Sent: 28 November 2017 13:44
To: Roger Spencer
Cc: Richard Temple; Planning.Responses; Planning; Ian D Solkin MIH
Subject: Ref Planning Application FP/268/17/PL

PROPOSED LOW TIMBER WALL

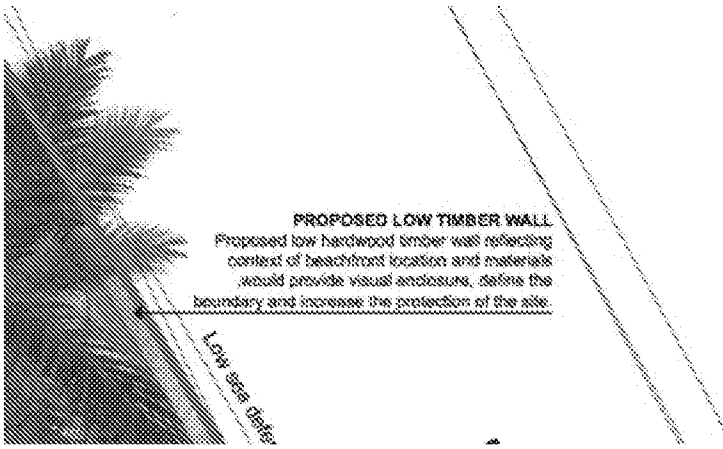
Thank you for your consultation response dated 21/11/17, in respect of the above planning application, the contents of which are appreciated.

However, can I please draw your attention to our landscaping drawing and landscape design strategy, both these documents make reference to a hardwood timber wall behind the existing sea defence wall, within our landscaped area along the eastern boundary, to act as a secondary line of defence. This timber wall will be slightly set back from the existing sea defence wall at the back of the promenade and will be some 500 mm higher than the existing sea defence wall.

I have attached a screen shot of the note on the landscaping drawing for your information.

Proposed low hardwood timber wall reflecting
context of beachfront location and materials
would provide visual enclosure, define the
boundary and increase the protection of the site.
